Subject: AP1000 Response to Request for Additional Information (SRP TR85 and 3.8.3)

Response to Request for Additional Information on SRP TR85 and 3.8.3

RAI Response Number: RAI-SRP3.7.1-SEB1-19
Revision: 0

RAI Response Number: RAI-SRP3.8.3-SEB1-03
Revision: 2

Figure RAI-SRP3.7.1-SEB1-19-02: Stress strain curve of an element showing minimal cracking

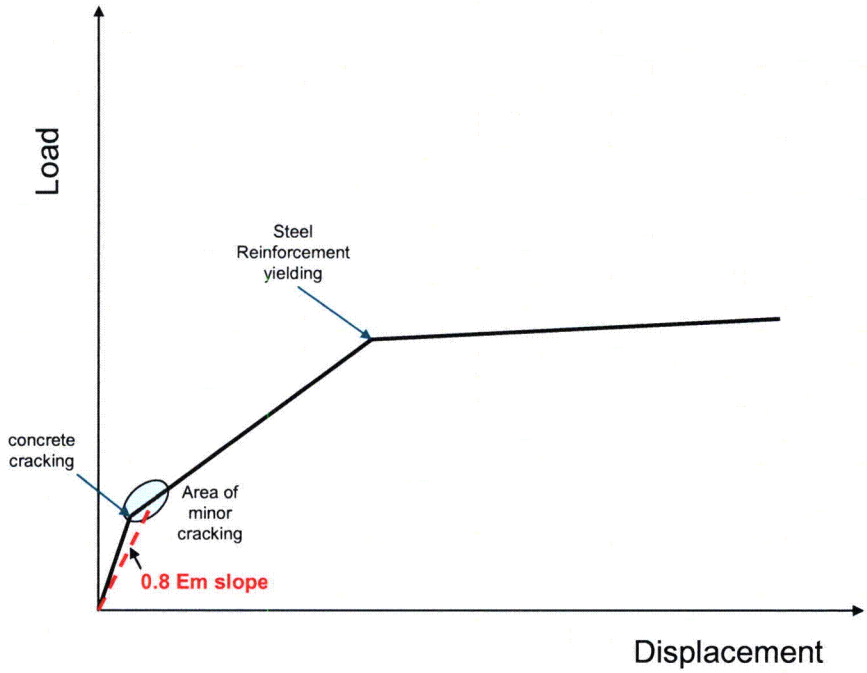
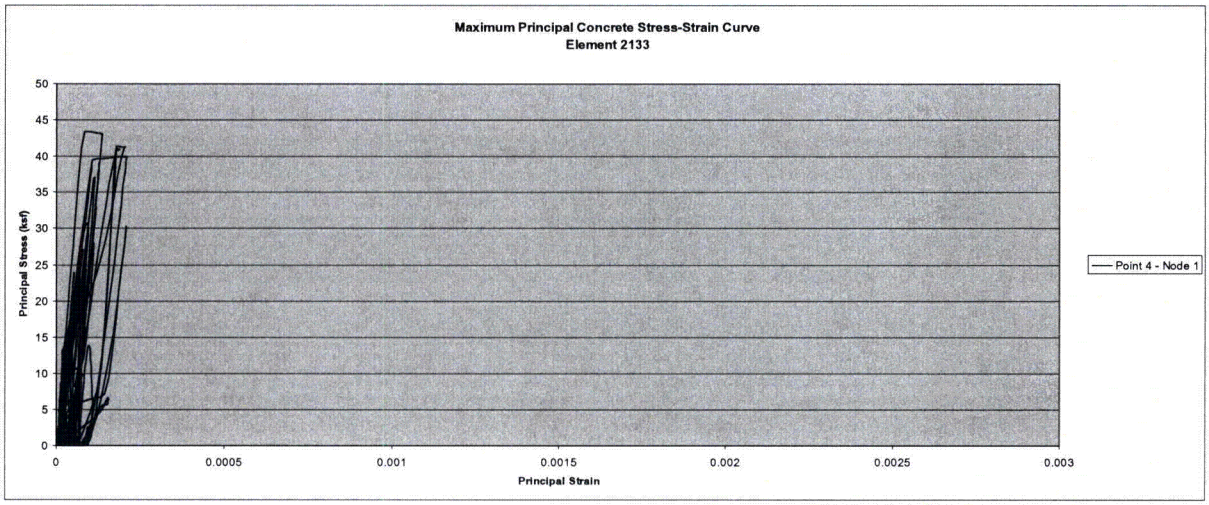
With DCD, Revision 17, the applicant changed the design of the shield building (SB) from reinforced concrete (RC) construction (7% SSE damping in DCD Table 3.7.1-1) to concrete-filled steel module (SC) construction (5% SSE damping in DCD Table 3.7.1-1). The staff performed a review of TR-03, Revision 4, to verify the critical structural damping values used in shield building dynamic analysis. The applicant did not provide information in this regard, so staff issued RAI-SRP3.7.1-SEB1-19 (a) (draft sent 4/29/2010), requesting the applicant to define the damping value(s) used for the SC module walls and to describe how this value is assigned in the ANSYS and SASSI models.

The staff also found that the applicant reduced the SB concrete modulus to 80% of nominal value, to account for concrete cracking. The 80% value is recommended by FEMA when there is little load-induced cracking. Therefore, the staff is assuming that the applicant has confirmed the seismic response level of the shield building is sufficiently low such that only minor concrete cracking occurs due to seismic loading. Damping has been recognized for many years as being a function of the structural response level. At low response levels, lower effective viscous damping has been observed; at high response levels, higher effective viscous damping has been observed The staff is concerned that SSE damping may not be appropriate to use in the shield building dynamic analyses that are relied on for generation of in-structure response spectra (ISRS). In RAI-SRP3.7.1-SEB1-19 (b), the staff requested the applicant to document in TR-03 the technical basis for the damping value assigned, in light of the observed dependence of damping on response level.

The models presented in TR03 follow the damping criteria stated in DCD Table 3.7.1-1 using 5% SSE damping for all steel composite (SC) structures, including the Shield Building wall and modules, and 7% SSE damping for the remaining reinforced concrete (RC) structures throughout the Nuclear Island (NI). The linear structural damping values were defined in SASSI and ANSYS as a parameter of material property defined for each element. This form of structural damping is used for seismic time history analyses. The use of these damping values is justified if the element stresses in the model approach their cracking limit. A typical SB element is provided in Figure RAI-SRP3.7.1-SEB1-19-02, where cracking is present at a tensile stress of around 43 ksf.

The question of whether 80% Em is an appropriate value can be assessed using Figure RAI-SRP3.7.1-SEB1-19-01. Figure RAI-SRP3.7.1-SEB1-19-02 shows the idealized in-plane behavior of an SC wall. The figure shows a region that would be considered minimal cracking, and where the secant stiffness would be very close to 0.8 Em value. The figure shows the

stress strain curve for a typical element in the SC cylindrical wall. It shows that only minor cracking is occurring for that element. These results are consistent with those shown in the Shield Building report, Appendix B, where isometric views of the nuclear island show that although cracking occurs throughout the nuclear island the level of cracking is minimal.

Figure RAI-SRP3.8.3-SEB1-03-01: Enveloped RS at El. 60.5' and AP1000 CSDRS in X direction

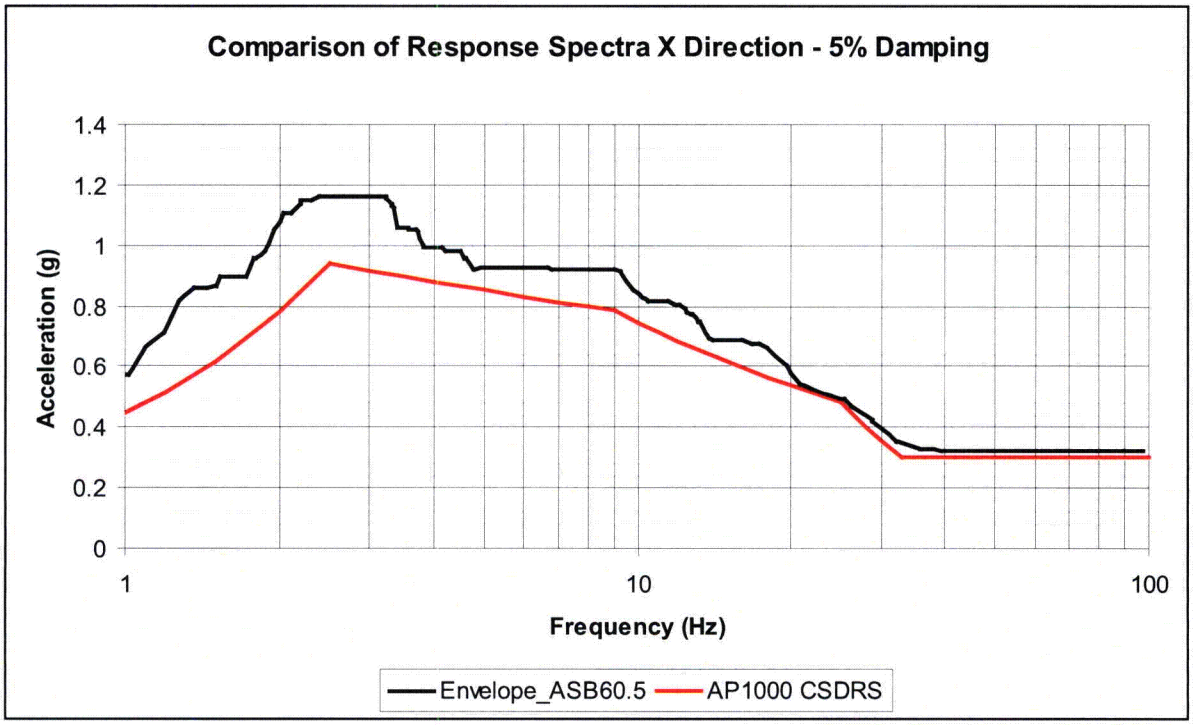
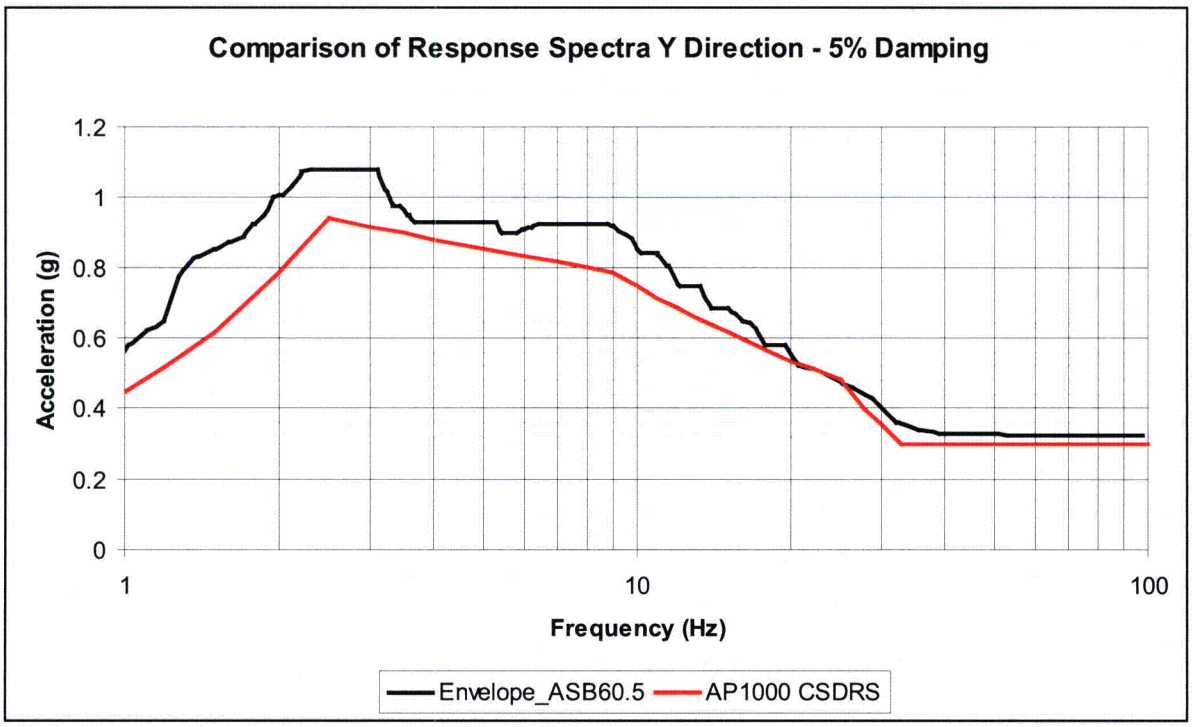
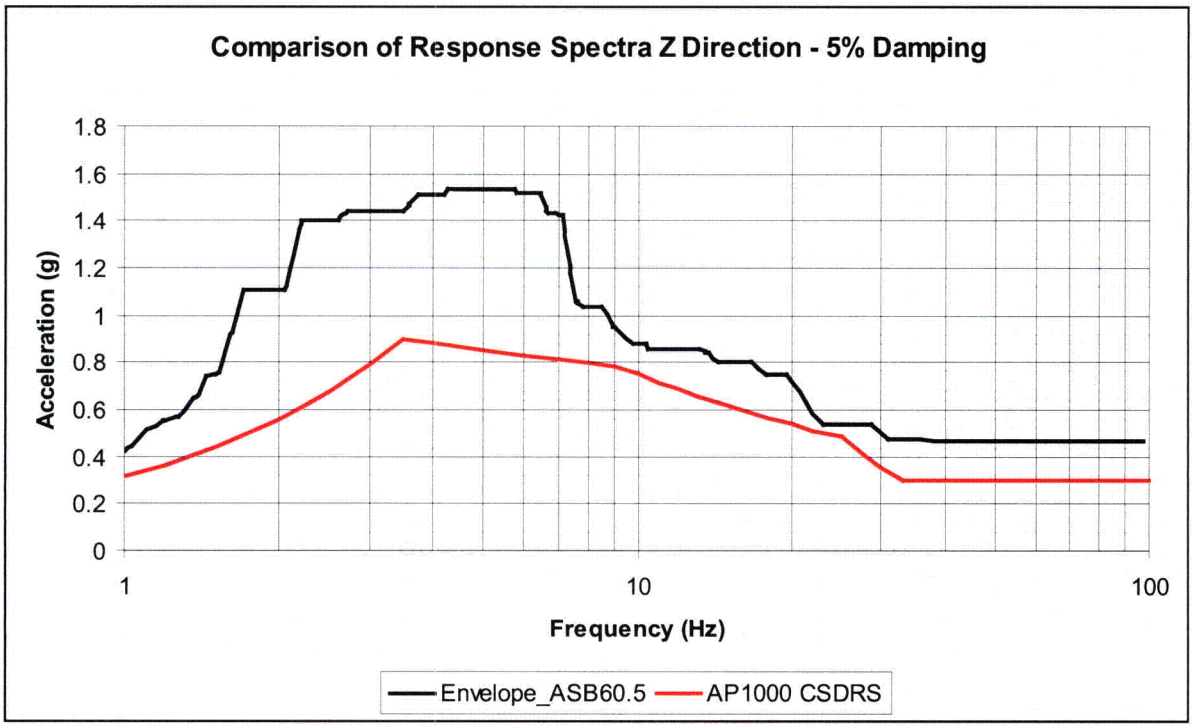
1. Describe methodology for generation of FRS at 5 locations (3 applicable key locations (ASB control room floor, ASB fuel building roof at shield building, ASB shield building roof area) and 2 additional locations at Aux building that include highly stressed regions).
   - Abaqus
   - ANSYS
2. Compare the FRS from both methods at the 5 locations (3 applicable key locations and 2 additional locations at Aux building that include some higher stressed region).
3. Provide stress strain time history curves at 2 locations (1 Shield building and 1 Aux building). Show that no significant energy absorption occurs.
4. SC/RC connection
   - Describe methodology for modeling/analysis (accounting for current connection design).
   - Show that varying stiffness values does not significantly affect the response of the SB.
5. Provide discussion of the results and justification.

The all soils input time history was developed by taking the enveloped CSDRS at elevation 60.5', and creating a statistically independent time history. In Figures RAI-SRP3.8.3-SEB1-03-01 through RAI-SRP3.8.3-SEB1-03-03, the enveloped Response Spectra (RS) for all soil sites at Elevation 60.5' are presented and compared against the AP1000 Certified Seismic Design Response Spectra (CSDRS) at 5% damping in the directions of North-South (X), East-West (Y) and Vertical (Z), respectively.
